Reference: McGuire Nuclear Station
Docket Nos. 50-369, 50-370

Please find attached additional information concerning the McGuire Nuclear Station spent fuel pool two region rerack modifications. This additional information was requested by a June 11, 1984 telecopy from Franklin Research Center to Duke Power which concerns the spent fuel pool structural analysis.

DUKE POWER COMPANY
MCGUIRE NUCLEAR STATION
Spent Fuel Pool Rerack Modifications
Additional Information

Sample Calculation

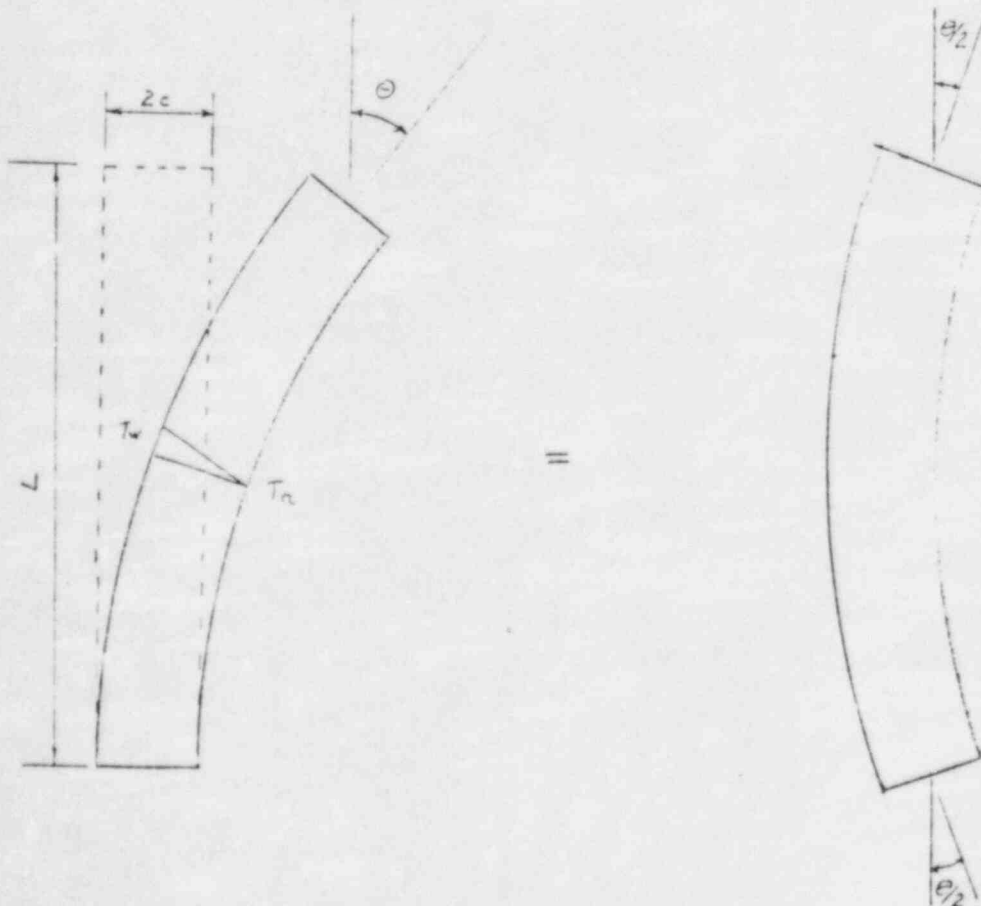
The licensee has stated that the thermal gradients were determined by the use of 'ANSYS finite element computer code,' for analysis by 'STRU DL program.' Please indicate if the analysis was based on uncracked or cracked sections, and provide sample calculations.

Thermal gradients are determined via ANSYS thermal analysis as indicated in Section 3.1 of the license submittal. Thermal gradients then are used to derive thermal growth and rotational distortions. It is then determined what moments must be applied to result in zero net end rotation. These moments are applied step-wise. Reduced flexural stiffness is accounted for if moment in the member exceeds that required to cause cracking. The final moment required to obtain zero net end rotation is applied to the structure through member end loads.

Calculate end rotation of cantilever member

$$= \frac{\alpha \times (T_w - T_a)}{2c} (L)$$

Rotate ends until $\theta = 0$ allowing for varying stiffness as cracks propagate through the member.

The Moment - end rotation relationship is obtained by creating a beam model in STRUDL composed of short beam segments all initially with equal member properties. As ends are rotated, a moment develops in the beam segments until $M = M_{cr}$. Beyond this point, additional rotation results in cracking of the beam at constant moment = M_{cr} , until the entire member is cracked. This phenomenon is accounted for by changing the properties of individual beam segments as the end rotations are increased in step-wise fashion. Once the entire member is cracked, further end rotation results in increasing Moment at a reduced rate. Thus a given thermal rotation, restrained by end fixity can be related to an applied end moment.
